NMGH Modular Offices
Crumpsall, Manchester

RIBA Stage 4 Acoustic Design Review

P1919-REP01-REV C-BDH

16 February 2021

Figure B2: First and upper floor Sound Insulation mark-up

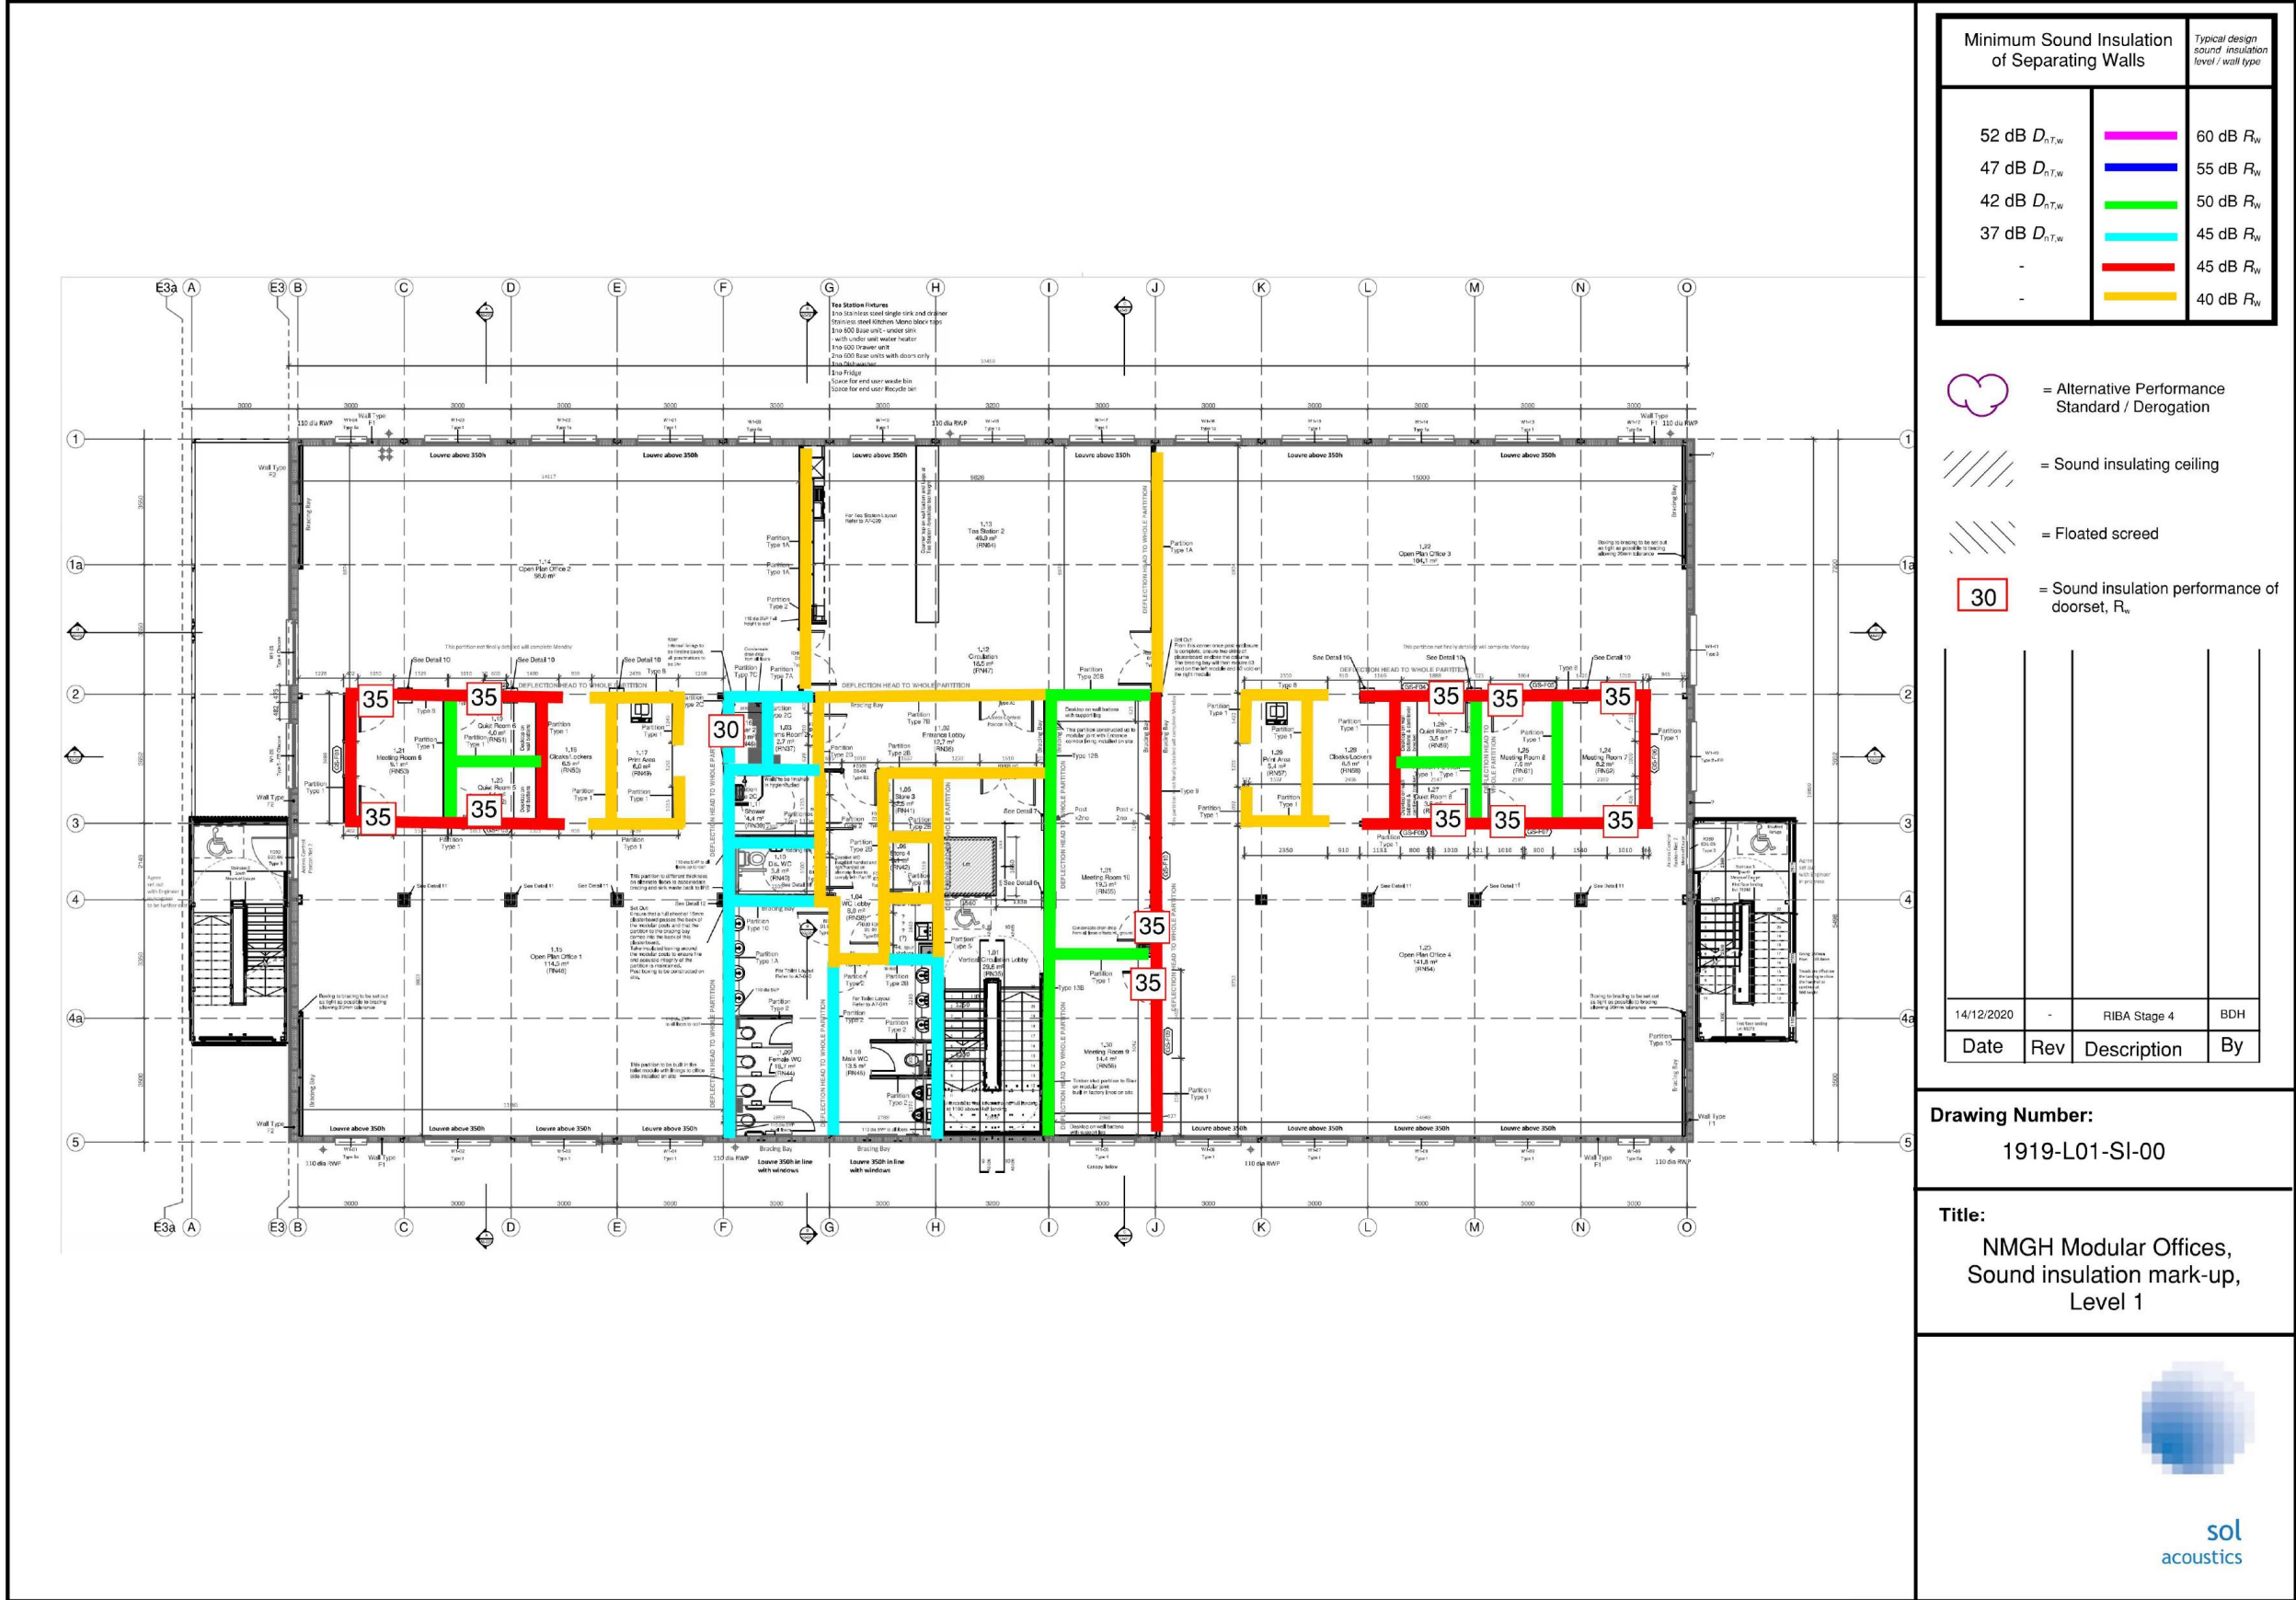
Full height glazed screens are proposed for the partitions separating the quiet rooms and meeting rooms from the adjoining open plan offices. The sound insulation performance mark-ups as provided in Appendix B confirm that these partitions (including the glazed screens) are required to provide achieve a laboratory sound insulation performance of 45dB R_w . This is a very high sound insulation performance to be achieved by a glazed screen and is likely to require the use of acoustically laminated double glazing.
